TO: Mercedes-Benz Dealer Principals, General Managers,	FROM: Gregory Gunther, Department Manager, Vehicle
Sales Managers, Service Managers, Parts Managers	Compliance and Analysis, Engineering Services
RE: Recall Campaign - Launch Notification	
Inspect Mounting of Rear Door Trim Bars	DATE: April 21, 2023
MY22-23 GLE and GLS (167 and X167 platform)

Recall Campaign Launch Notification

Campaign No.:	NHTSA ID	Campaign Desc. :	Inspect Mounting of Rear Door Trim		
2023040011	23V178	23P7490003	Bars		
2022-2023 GLE	This is to notify you of a Recall Campaign Launch to inspect the mounting of the rear door trim bars on 70,225 Model Year ("MY") 2022-2023 GLE and GLS (167 and X167 platform) vehicles. The recall campaign will be visible on the www.safercar.gov				
website and may	generate quest	ions from customers. Affected V	INs will be flagged in VMI as "OPEN" on April 21, 2023.		
		Backgrou	ınd		
Issue		Mercedes-Benz AG ("MBAG"), the manufacturer of Mercedes-Benz vehicles, has determined that on certain Model Year ("MY") 2022-2023 GLE and GLS (167 and X167 platform) vehicles, the fastening of the rear door window trim bars might not meet current production specifications. Under certain driv

Figure 1 Figure 2

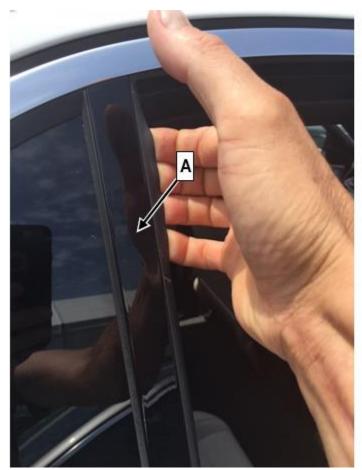
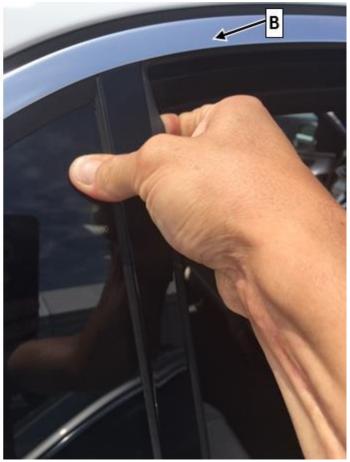
2. Check whether right and left window dividers (A, Figure 1) are seated tightly.

To do so, grasp the window divider in the upper area with your hand (Figure 1) and support it with your thumb on the fixed window (see Figure 2).

Then pull the window divider outward carefully (approx. 100 N / 22.5lbs of force) to check whether it is seated tightly.

1 The window divider must *not* work loose.

Ensure that the window divider is *not* jammed under the trim bar on the window frame

(B, Figure 2). This could cause a test error with regard to the holding ability of the trim element on the window divider. A gap of 1 mm from the window divider (A) to the window frame (B) is normal.

- a. Window divider (A) works loose: Carry out inspect/test procedure B.
- **b.** Window divider (A) does *not* work loose: **End measure**.

Figure 3

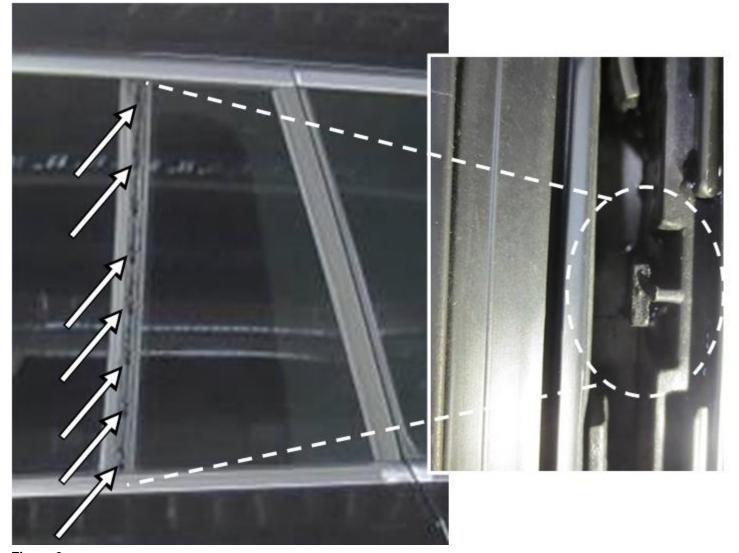
- i If window divider is loose.
- 1. Remove window divider completely and check **holder for window divider** on frame of triangular window.
 - i If no damage is visible, reinstall window divider and check again whether it is tightly seated

- a. Holder for window divider broken: Carry out work procedure.
- **b.** Holder for window divider *not* broken: **End measure**.
 - includes: Re-assembly of window divider
